FASHION SQUARE MALL MASTER PLAN AND DRI AMENDMENT

<p>Updated: May 20, 2014</p>	<p>Master Plan approval to add multi family</p>

MASTER PLAN APPROVAL / DRI AMENDMENT AREA

PROPOSED STREET CROSS SECTIONS

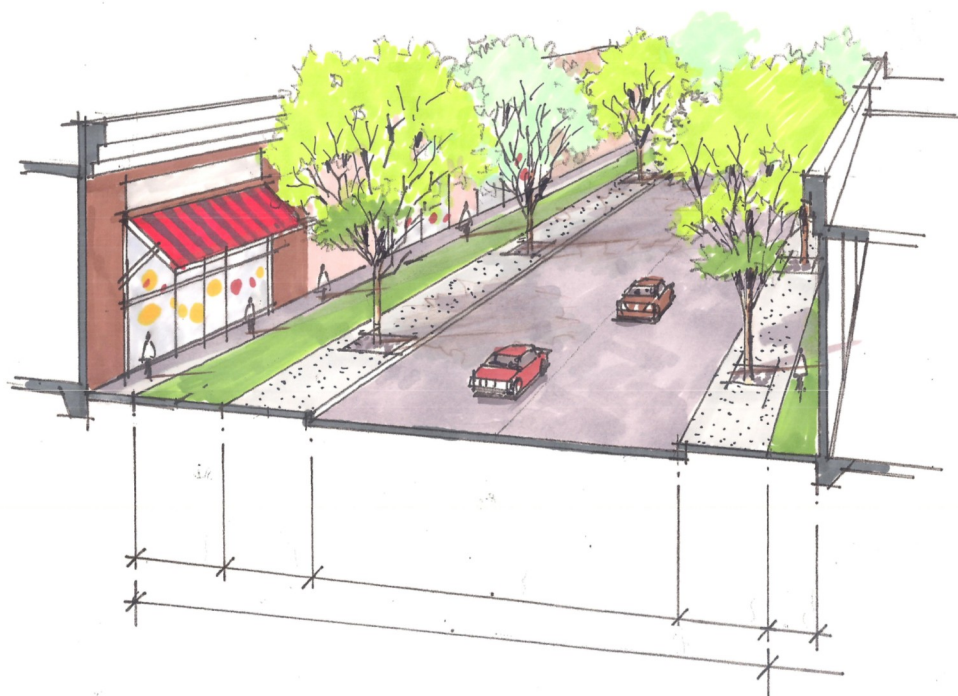
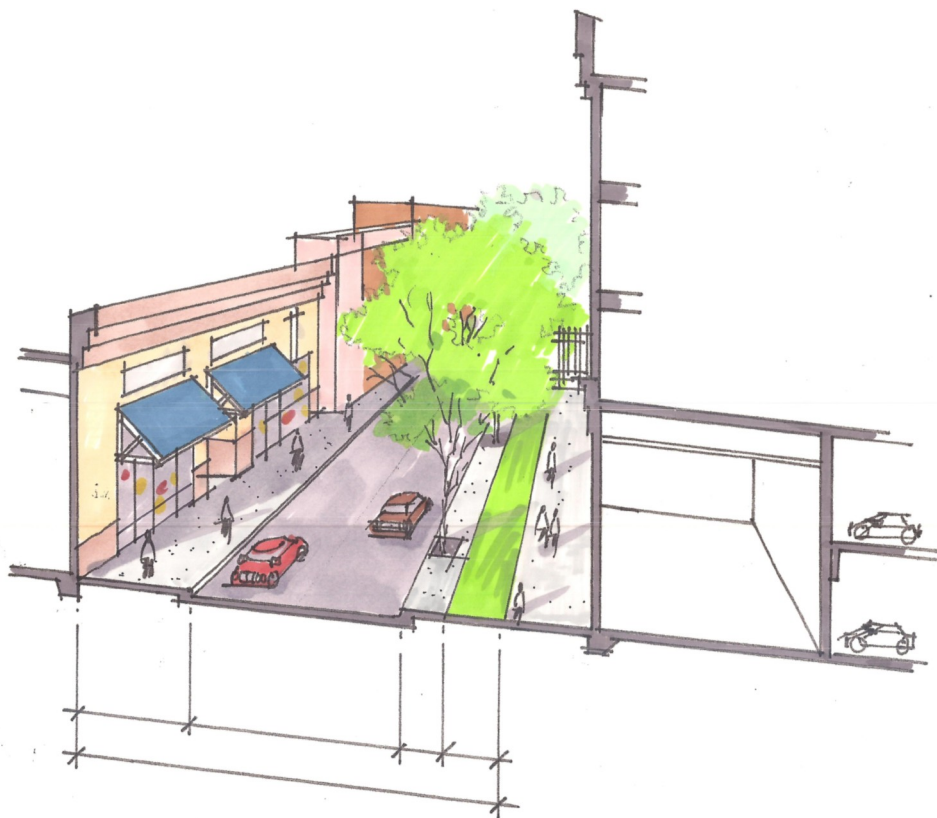
2. BICYCLE AND PEDESTRIAN TRAIL REQUIREMENT: The "Section C" roadway cross section shall be revised to move the bicycle/pedestrian trail four (4) feet away from the curb and any lateral structures (FDOT PP Manual 8.6.10 & 8.6.5). The bicycle and pedestrian trail path shall not contain any street furniture or landscaping in order to maintain a ten (10) foot clear path.

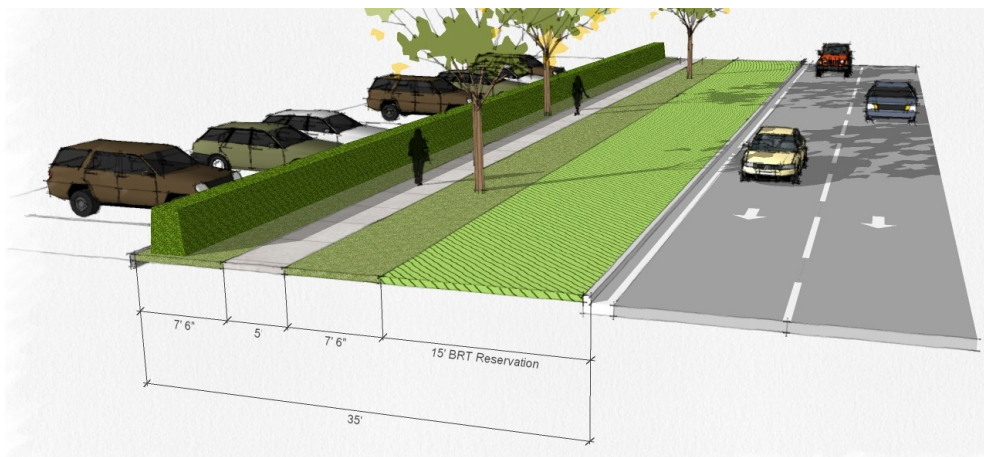
10. **CROSS-ACCESS CORRIDOR REQUIREMENTS:** The subject property is adjacent to a major thoroughfare, Colonial Drive. Orlando Land Development Code (LDC), Chapter 61 (Sections 61.108 – 61.113), provides the minimum requirements for cross-access corridors. The subject development shall provide cross-access easements to the applicable adjacent properties to ensure that the parking, access, and circulation may be easily tied in to create a unified system.
